RE: PROPOSAL NO. R10 Childcare Fence Extension

## ADDENDUM NUMBER TWO

## CHAINLINK FENCE

**MOUNTAIN VIEW  
HAND BALL COURT  
CITY OF MOUNTAIN VIEW**

**AD1.01**

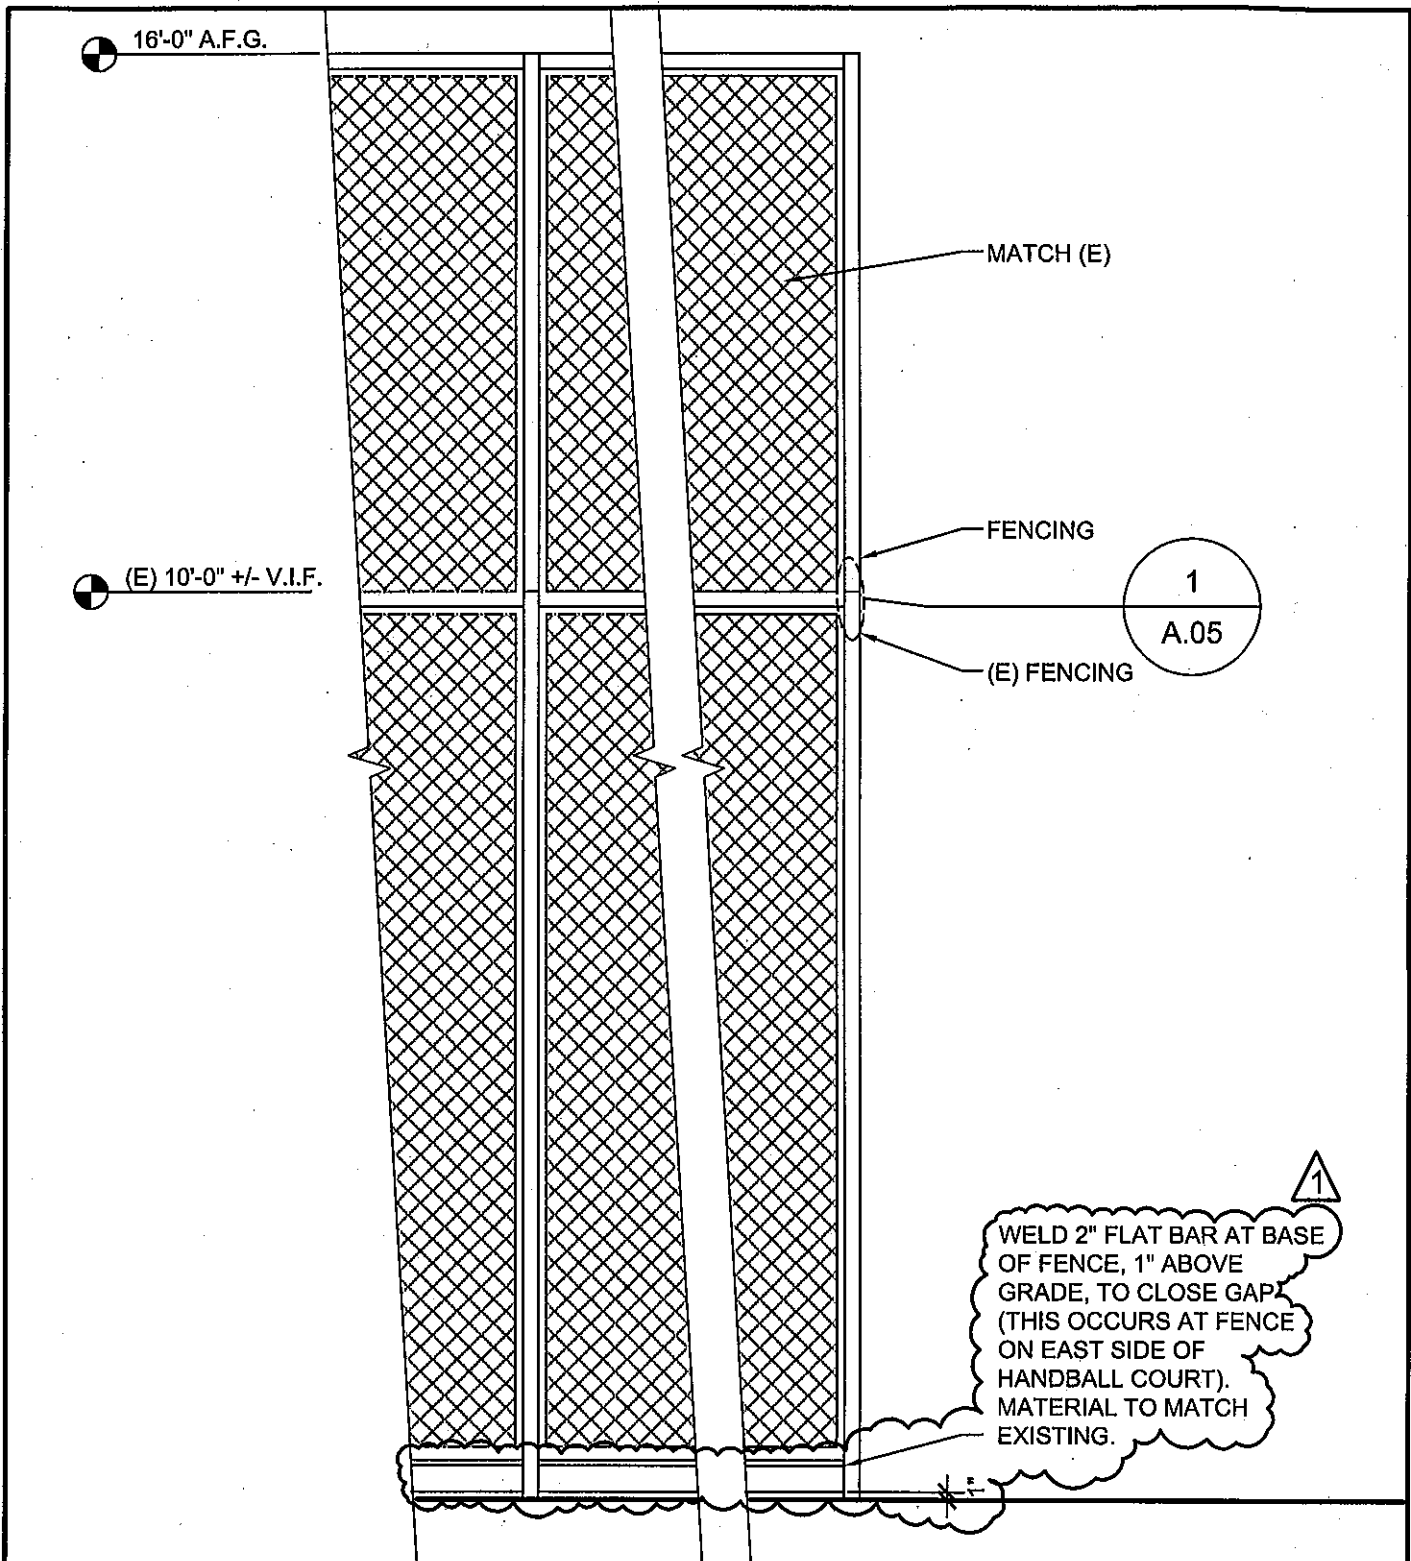
Item 3: Revise sheet A.05 Chain link Fence per sheet AD1-01 attached to this addendum.
